COUNTRY CLUB COURT SUBDIVISION, **RESUBDIVISION OF LOT 2**

APPLICATION NUMBER 17 DATE August 16, 2007

REQUEST Subdivision

DETAIL SITE PLAN

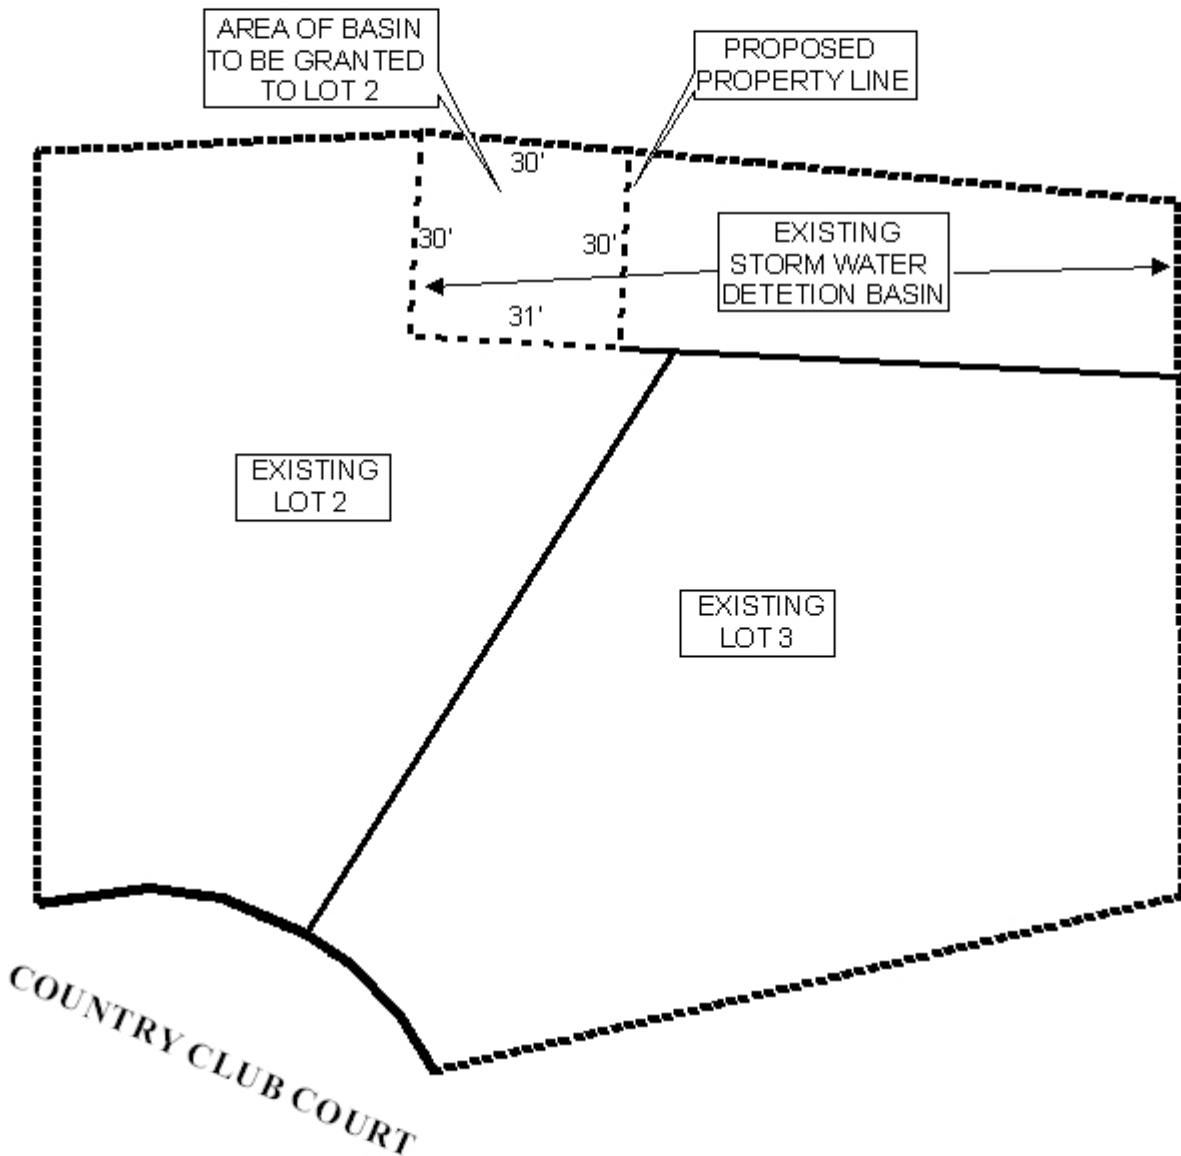
Another issue relates to the fact that the subdivision will reduce common area that is designated as/for a detention basin for the entire subdivision. Documentation that this reduction in area would not impact the performance of the detention facilities was not provided. While at first blush this may appear as appropriate for a condition of approval, it is more appropriate as a required document for tentative approval.

Generally, subdivisions are not required to have their detention fully engineered or designed at the time of Tentative Approval. However, this is not the typical subdivision application. In this instance, the detention facilities have been designed and constructed. The application is now requesting that the common area containing those facilities be reduced and incorporated into a private lot. Based upon the plat submitted, there is no information regarding the exact location of the detention basin, if it is fully within the remaining common area or partially located on the private lot.

- 1) documentation of authorization to file the application;
- 2) documentation that the reduction in the common area would not impact the performance of the detention facilities;
- 3) depiction of the detention basin structure on the plat.

Based on the preceding, it is recommended that this application be held over until the September 20th meeting, with required information submitted by August 27th, to allow the applicant to address the following:
